Department of Energy

TRANSMITTAL OF REPORT *TECHNICAL BASIS DOCUMENT NO. 12: BIOSPHERE TRANSPORT* ADDRESSING SEVEN KEY TECHNICAL ISSUE (KTI) AGREEMENTS RELATED TO BIOSPHERE TRANSPORT

1. *Technical Basis Document No. 12: Biosphere Transport*, Revision 1 (hard copy)
2. CD of Enclosure 1

Figure B-1. Rate of Change in Mass Loading from a Hypothetical Initial Concentration of 10 mg/m^3 for Five Values of the Mass Loading Decrease Constant

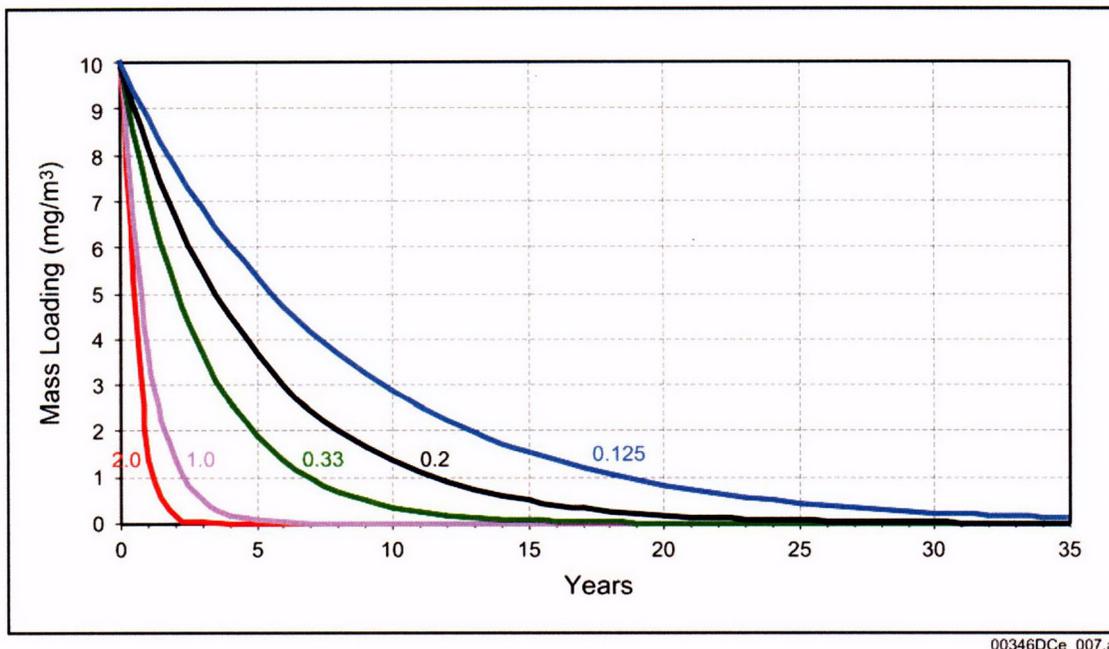
Provide information clarifying the method used in TSPA to calculate how deposit thickness effects the average mass load over the transition period. DOE will provide information clarifying the method used in TSPA to calculate how deposit thickness effects the average mass load over the transition period in a subsequent revision to the AMR Input Parameter Values for External and Inhalation Radiation Exposure Analysis (ANL-MGR-MD-000001) or equivalent document. This will be available to the NRC in FY02.

This agreement item requires an explanation of the methods used to model the effects of tephra-deposit thickness on concentrations of resuspended particles (i.e., atmospheric mass loading). This item is based on the concern by the NRC that the mass loading distribution used for the site recommendation and the associated methods used to model decreases in mass loading following a volcanic eruption do not adequately incorporate variation and uncertainty due to the thickness of the tephra deposit at the location of the receptor. Specifically, the NRC was concerned that the distribution of mass loading used was not representative of conditions that would occur over a thick deposit, and that the methods used to account for decreases over time involved combining temporal variation with data uncertainty and were based on an assumption that mass loading would be proportional to thickness (NRC 2002, Section 3.3.13.4).

The methods used in the TSPA to calculate dose following a volcanic eruption have been substantially revised. The most important change relevant to this issue is that the influence of ash depth on initial mass loading, the proportion of particles that are radioactive, and the rate of decrease of mass loading now are considered separately in the TSPA. This revised modeling approach is summarized in Section 5 and described in detail in the *Biosphere Model Report* (BSC 2003c, Sections 6.3.2 and 6.5).

The mass loading time function, $f(t)$, describes the rate of change in mass loading and the associated inhalation dose after a volcanic eruption. This function is implemented in the TSPA, as shown in Equation B-2 (BSC 2003d, Section 6.3; BSC 2003c, Section 6.5.8).

The conditions at the locations where mass loading was measured following the eruption of Mount St. Helens generally are analogous to tephra-deposit thickness and climatic conditions predicted for the area south of Yucca Mountain. Ash thickness ranged from about 1 to 10 mm at four analog sites in eastern Washington from which mass loading measurements were considered (BSC 2003d, Section 6.2.2.3). This is similar to the ash depth predicted during most realizations

Figure D-1. Biosphere Dose Conversion Factor Values Plotted as a Function of K_d for Plutonium-239

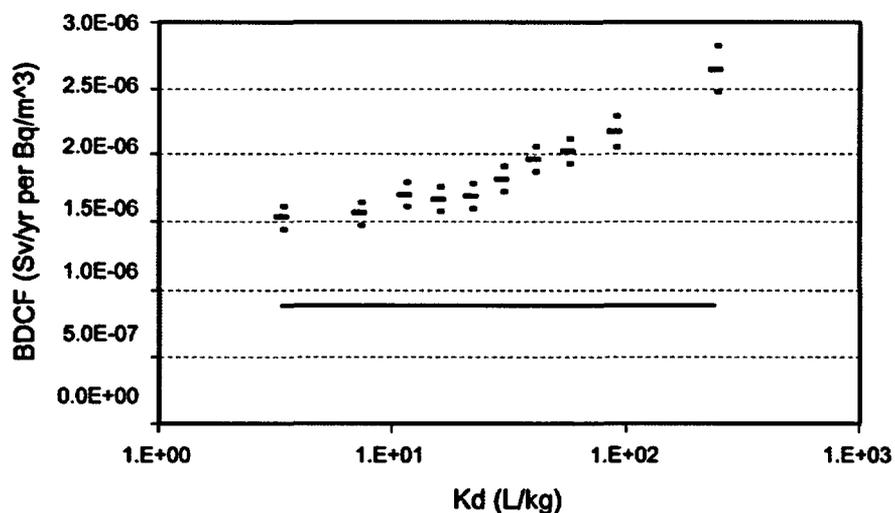
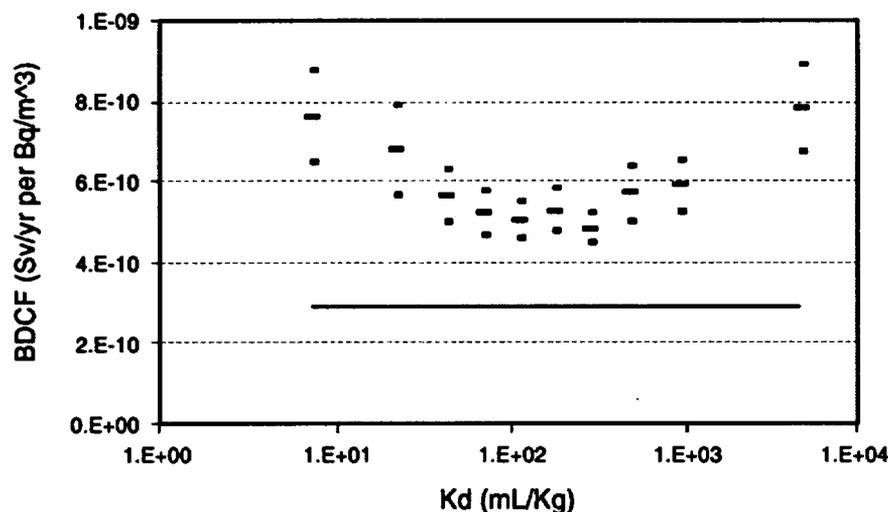
Provide justification that the K_d values used for radionuclides in the soil in Amargosa valley based on the results of a literature review are realistic or conservative for actual conditions at the receptor location (DOSE2.2.1). DOE will provide justification that the K_d values used for radionuclides in the soil in Amargosa Valley are realistic or conservative for actual conditions at the receptor location. The justification will be provided in Evaluate Soil/Radionuclide Removal by Erosion and Leaching AMR (ANL-NBS-MD-000009) or other document expected to be available to NRC in FY 2003.

To illustrate the overall effect of the uncertainty in the K_d values on the BDCF distributions, an analysis was conducted on the biosphere model outputs used to generate the BDCFs for the groundwater scenario for TSPA. One thousand stochastic realizations were performed using the model for radionuclides of interest (BSC 2003d, Section 6). The BDCFs for a given radionuclide are the result of sampling more than 100 input parameter distributions defined in *Nominal Performance Biosphere Dose Conversion Factor Analysis* (BSC 2003d, Section 6.2). When these results are viewed as 1,000 data points on a plot of BDCFs as a function of K_d , it appears that the sampling of many individual input parameters masks information on the trends in the data. However, if the data pairs (i.e., a sampled K_d value and the calculated BDCF value) are first sorted in ascending K_d order, some trends can be seen when the data are placed into 10 groups of 100 data points (Figures D-1 to D-3). Each of the 10 groups is represented by the mean values of their K_d s and BDCFs. This procedure reduces the statistical noise apparent in the original data. Using standard sampling theory and the standard deviation of each group of data allows an estimate of the 95th percentile confidence limits of the mean value of each group to be made (Figures D-1 to D-3). This analysis was done for three representative radionuclides. Radionuclides were chosen to represent distributions with high (plutonium-239), moderate (neptunium-237), and low (technetium-99) mean values of K_d s. Also shown in Figures D-1 to D-3, as a horizontal line, is the contribution of water ingestion of two liters per day (10 CFR 63.312[d]) to the BDCF. The BDCF component attributable to drinking water represents the lowest value that the BDCF could reach if other pathways were insignificant contributors.

The analysis showed that although the range of K_d values covers several orders of magnitude (Figures D-1 to D-3), the impact of these large changes in K_d values on BDCF values is less than a factor of two about the mean value. BDCF values for a radionuclide with high K_d (plutonium-239) as shown in Figure D-1 gradually increases with K_d value, but the BDCF appears to converge to a fixed value at high K_d values. It should be noted that the mean value for the eighth data point lies at about the lower 95th percentile confidence limit of the mean value of adjacent points. There is sufficient overlap of the confidence intervals of these points to attribute this low mean value to statistical variation from the sampling process rather than the manifestation of a physical process in the model.

For neptunium-237, an element with a moderate value of K_d , there is little change in BDCF values for K_d values at the low end of the range. In this region, leaching is efficient and little buildup is expected. At higher K_d values, the BDCFs increase due to retention in the soil.

The relative insensitivity of the BDCF value to order-of-magnitude changes in the K_d value, along with the conservative approach of using the saturation radionuclide concentration in the soil, adds confidence that the selection of the K_d values for the biosphere model is justified. If the data used in the soil model overestimate the BDCFs, the degree of overestimation above the drinking water ingestion pathway exposure is less than a factor of two (Figures D-1 to D-3).
